UNITED STATES PATENT AND TRADEMARK OFFICE

APPLICATION NO.	FILING DATE	FIRST NAMED INVENTOR	ATTORNEY DOCKET NO.	CONFIRMATION NO.
09/809,074	03/16/2001	Shinya Nagamatsu	204842US-8	5550

Office Action Summary	Application No. 09/809,074	Applicant(s) NAGAMATSU ET AL.	
	Examiner Quyen P. Leung	Art Unit 2828

DETAILED ACTION

FIG.2A

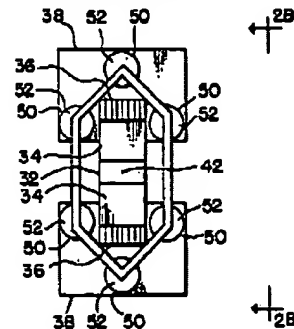
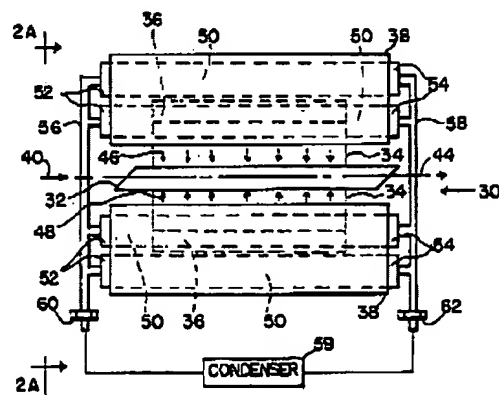
5. Claims 1 and 12 are rejected under 35 U.S.C. 102(b) as being anticipated by Miyake et al (4,791,634). Miyake et al discloses a light source (30) comprising a plurality of densely placed laser diode modules (36) mounted on a mounting portion (38), each of the modules (36) having an output of at least 100 mW (see math below),

and a plurality of heat pipes (50) thermally connected to the mounting portion (38), the plurality of heat pipes (50) having a heat absorbing portion (82) and a heat radiating portion with heat radiating fins (86).

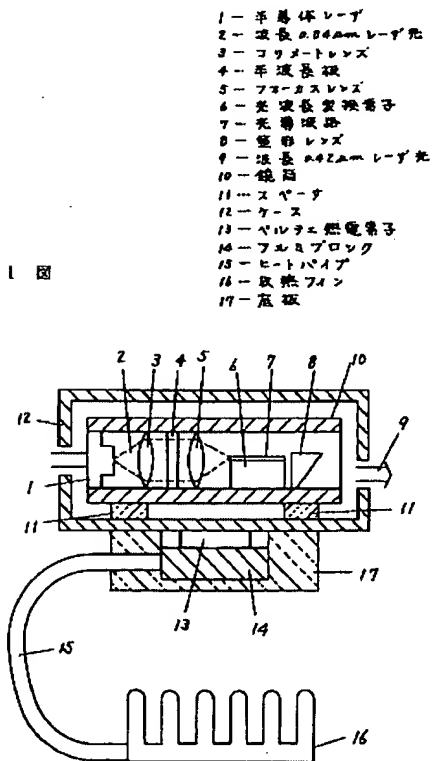
As evidenced in the above excerpts, it is inherent that each laser module produces at least 100 mW of output, because Miyake teaches that:

- (1) the laser modules (36) produce output of about 8 Watts/cm²,
- (2) the laser modules (36) comprise thin diode strips (102) interleaved with heat sink strips (104),
- (3) each thin diode strip has a dimension of 0.5 mm x 5 mm, or equivalently 2.5 mm² or 0.025 cm², and
- (4) each heat sink strip has a dimension of being 0.5 mm x 10 mm, or equivalently 5 mm² or 0.05 cm².

Considering each module to be one thin diode strip and an adjacent heat sink strip, the approximate area per module is therefore about 0.075 cm². Multiplying the

output per area (i.e. 8 Watts/ cm²) and the area per module (i.e. 0.075 cm²) results in 0.600 Watts/module, or equivalently 600mW/module.
